SUBDIVISION REVIEW SHEET

CASE NO.: C8J-2022-0273

SUBDIVISION NAME: Lagos Austin Section 2 Preliminary Plan

**CITY OF AUSTIN – TRAVIS COUNTY – SINGLE SUBDIVISION OFFICE
SUBDIVISION APPLICATION – MASTER COMMENT REPORT**

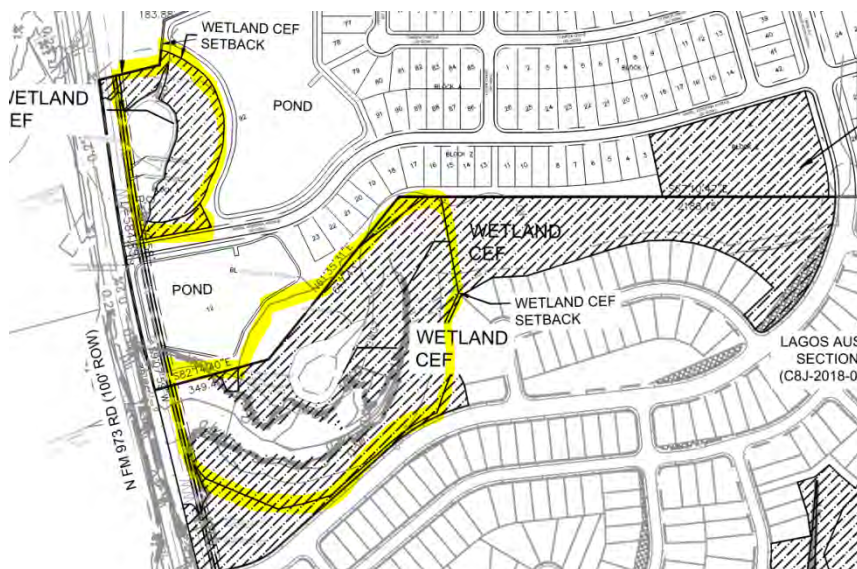
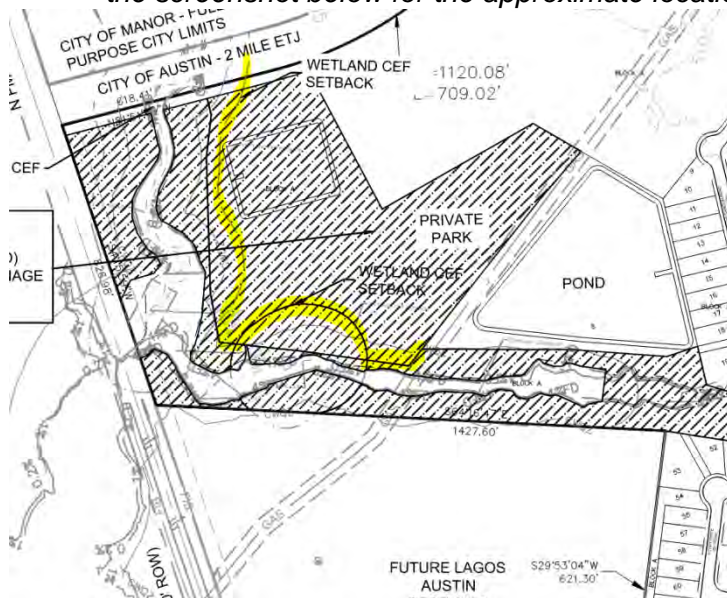
WB2. Update0. Demonstrate that this project complies with Critical Environmental Feature protection requirements and 1:1 mitigation for Critical Environmental Features. [LDC 25-8-281 or LDC 30-5-281; LDC 25-8-282 or LDC 30-5-282; ECM 1.10; ECM 1.10.4]

Additional information: {The current proposed limits of construction (LOC) encroaches within the standard 150-foot CEF setback. Provide an alternative protection/mitigation strategy compliant with and pursuant to ECM 1.10.4 for the setbacks. Alternative strategies must be appropriate and approved by this reviewer. Guidance can be found in ECM 1.10.4 The CEF setback must be modified and appropriate 1:1 mitigation must be established. This comment can be addressed by adding an additional note on EXH. I – CEF Mitigation Exhibit stating “To prevent mowing and future impacts to the CEF setback, split-rail fencing will be installed around the entire perimeter of the proposed CEF setbacks and associated signage indicating “CEF Setback: No Disturbance Allowed” will be installed.” See the areas outlined in yellow in the screenshot below for the approximate locations to install the fencing.}

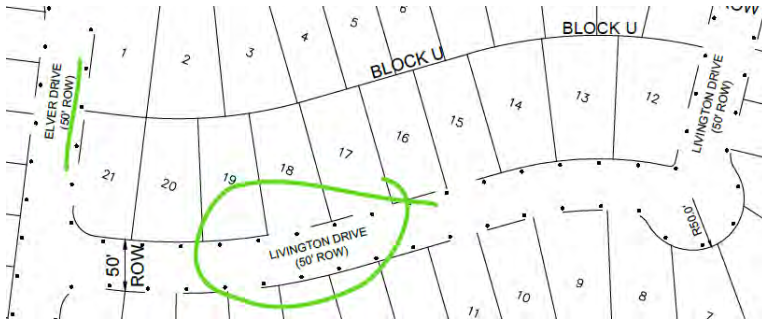
AD9: **VARANO CIR**- Phonetic duplicate with active street name, please reserve a replacement

AD10: Please choose an additional street name. When a street makes a 90 degree turn, it will be considered a different street and require a separate street name.

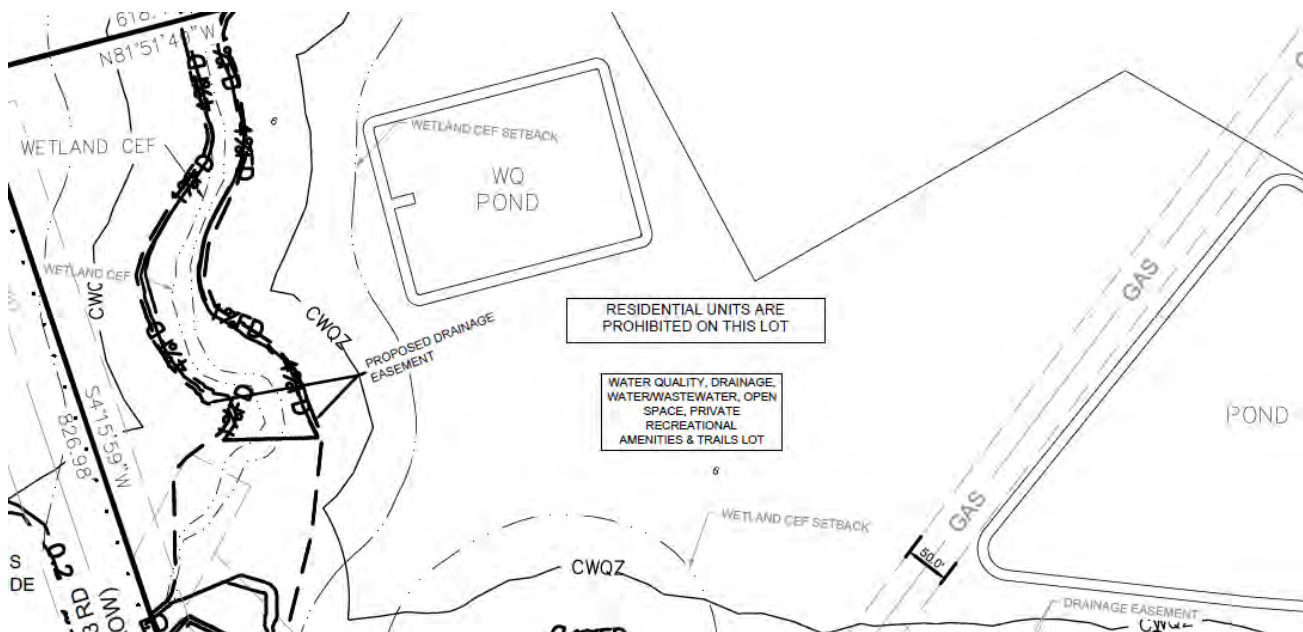
FP3: Check your left overbank and right overbank reach lengths. They should vary depending on the bend in the channel. Left and right overbank values should be measured from about where the 100-year flow is 2/3 contained. U2: Comment will be addressed during preliminary plan stage.

U0: Comment cleared.

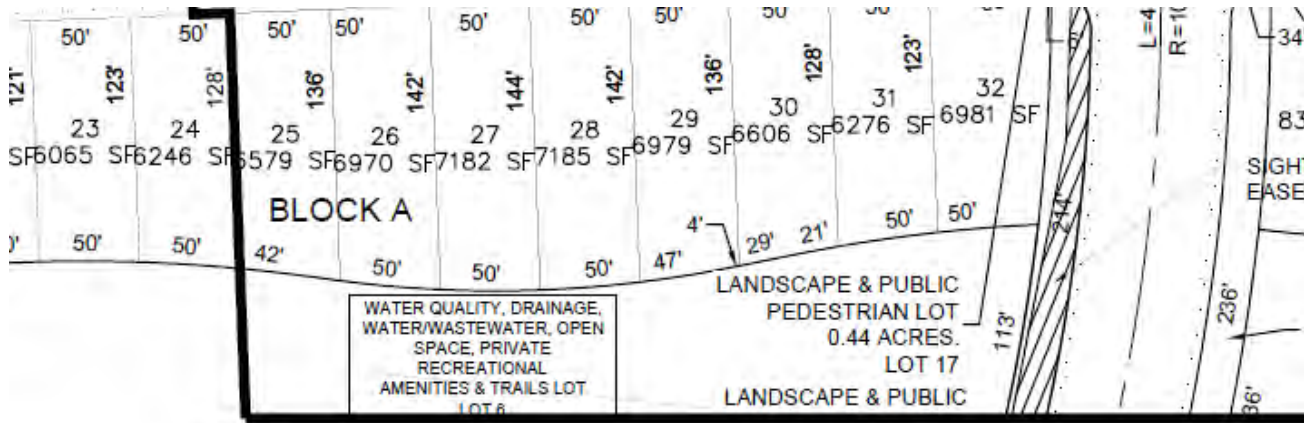
- AW1. Per Utility Criteria Manual Section 2, §15-9, §30-2, §25-5, §25-9, and the Uniform Plumbing Code:
Water and wastewater easements are not dedicated by preliminary plan, but rather by separate instrument through the site plan or construction plan process. Remove callout of water/wastewater from this lot callout, as well as throughout the preliminary plan on multiple sheets.

AND:

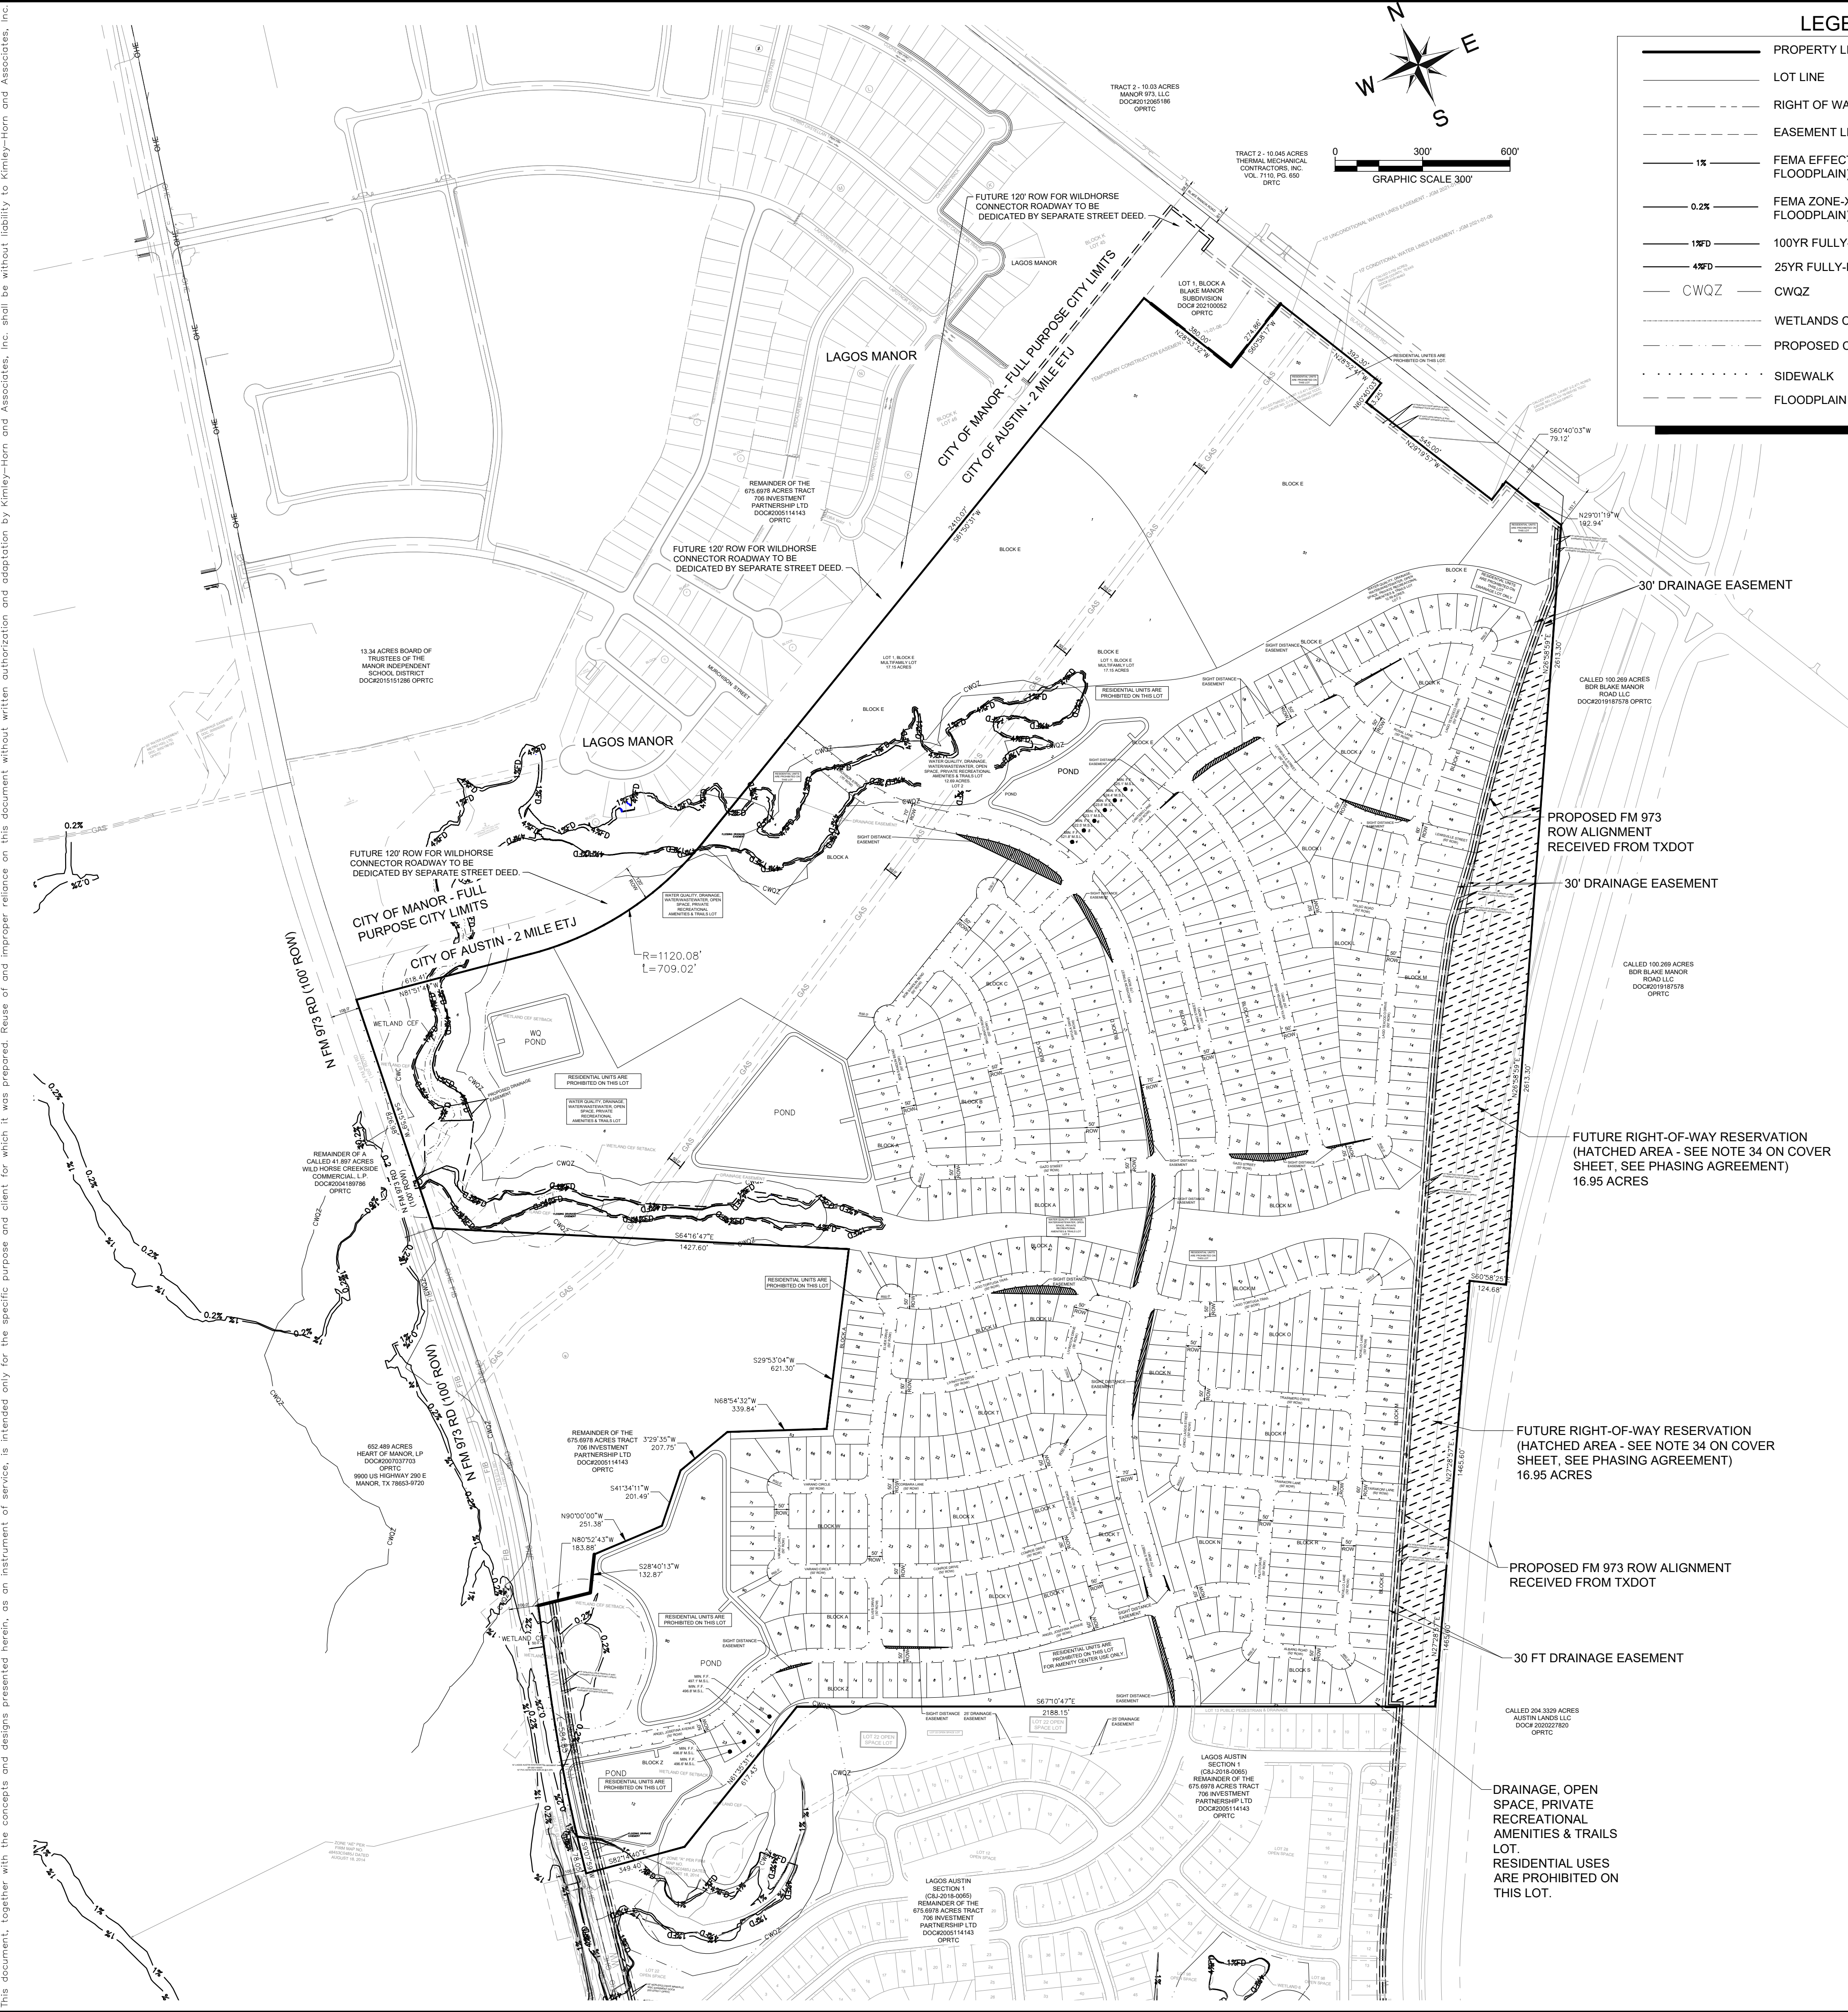
- ERM1. Update0.** Please demonstrate that the proposed crossings are compliant with LDC 30-5-262, LDC 30-5-364, and ECM 1.7 and therefore does not qualify as floodplain modification. Additional information: *{The proposed crossings (highlighted in yellow in the screenshot below) meet administrative variance to LDC-30-5-262-B3 and therefore does not require floodplain restoration ratios or mitigation ratios. 609s seeding and planting will be required to restore the areas disturbed within the City of Austin 100-year Fully Developed Floodplain. Please provide all details for planting and seeding meeting the minimum criteria of 609S (use the Table 5. Upland Species, Shade-Dappled Light Areas) to include the seed specification (species, total pounds, etc.) and the tree/shrub specifications (species, quantity, size, and location). Include a reference/call-out to the 609S planting and seeing for each of the three crossings highlighted above as well as the tables referenced.*

- a) *Add hatching/a call-out to 609S planting and seeding for Floodplain Modification for each of the three crossings highlighted above.*
- b) *Add a note stating "The proposed crossings meet administrative variance to LDC-30-5-262-B3 and therefore does not require floodplain restoration ratios or mitigation ratios. 609s seeding and planting will be required to restore the areas disturbed within the City of Austin 100-year Fully Developed Floodplain. All details for planting and seeding meeting the minimum criteria of 609S will be reviewed and approved at the subdivision construction plans stage."*
